# Performance and calibration of the NIKA camera at the IRAM 30m telescope

Comments by Rémi ADAM

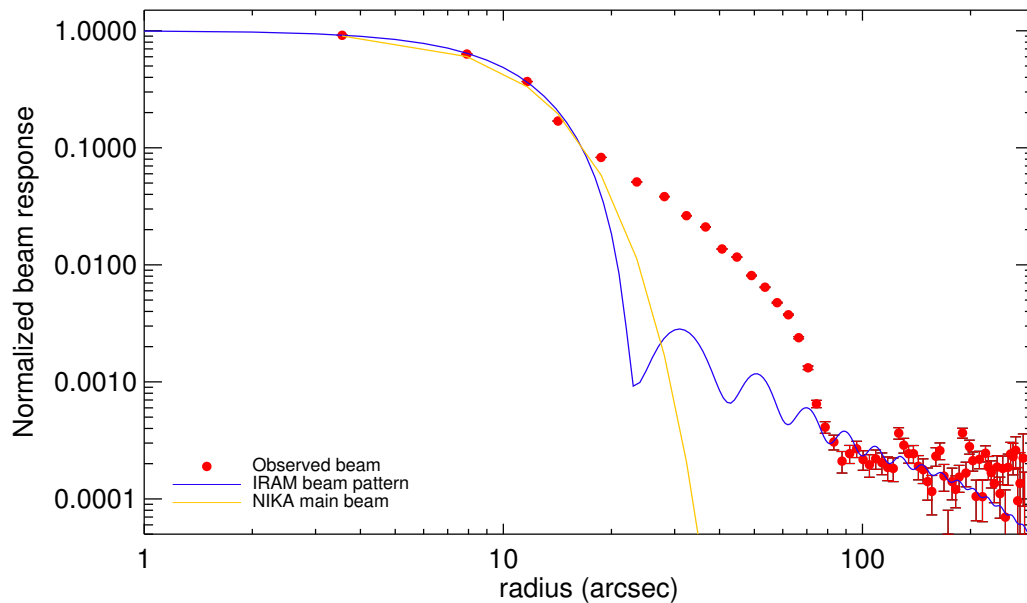
- I should clearly redo the Fig 8 plots (we need to discuss it as well as what is written in the caption). Here is shown a better profile but only at 2mm (I do not have the IRAM beam pattern at 1mm).

- Caption of Fig 8 :
    - I am not sure we should use the term far side lobe which might not correspond to what we have with NIKA.
    - " These maps are compatible with the the 2-dimensional...": the profile is clearly not compatible with the IRAM beam pattern so I do not think the map is compatible.
